Unit 4 Kitchen — To-Scale Sheet Set R8

1231 11th Ave, Unit 4, San Francisco · 2 Nov 2026 · R8: plain labels; sink drawn; switch & outlet proposal on K-S6/K-S7 · REVIEW DRAFT · English

K-S5 South run change record — sink moved in front of window

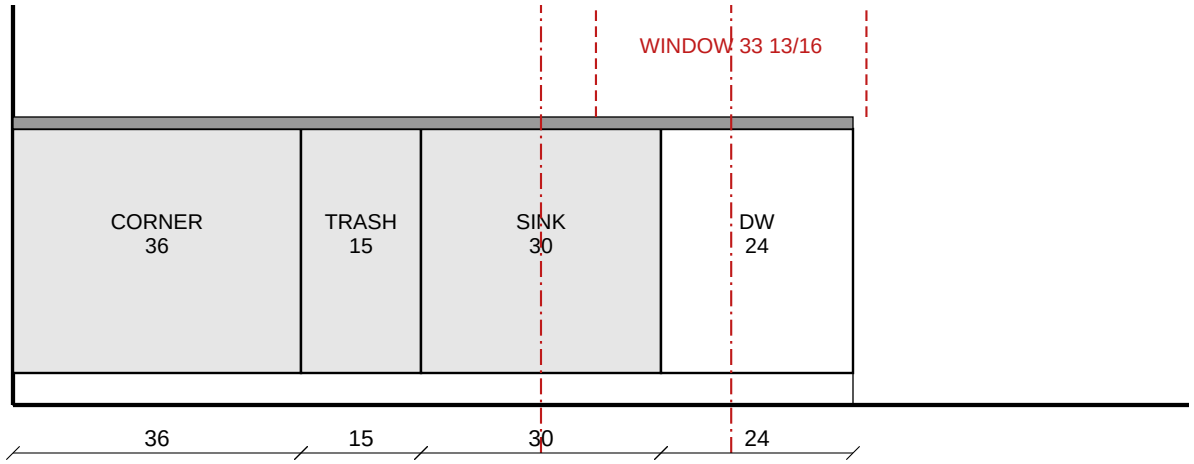
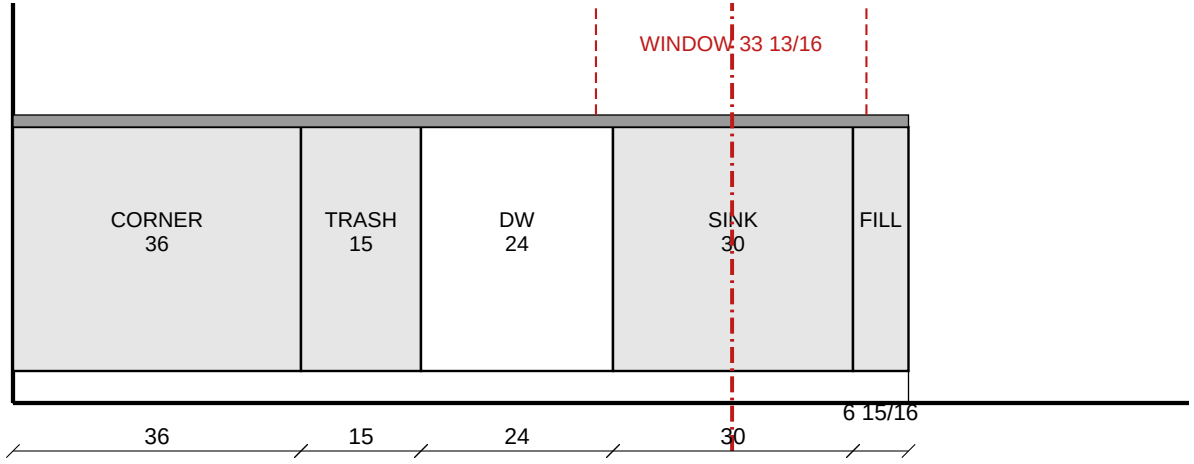
OLD: sink center 66, 23 3/4 off the window. SUPERSEDED.

CURRENT (Tisa's Magicplan 11/2): sink in front of window; DW between trash and sink; 6 15/16 filler at west end. Run 111 15/16; sink center 90. Pie-safe size TBD (Tisa).

Plumber: drain + supplies on 90. John confirms window position on site first.
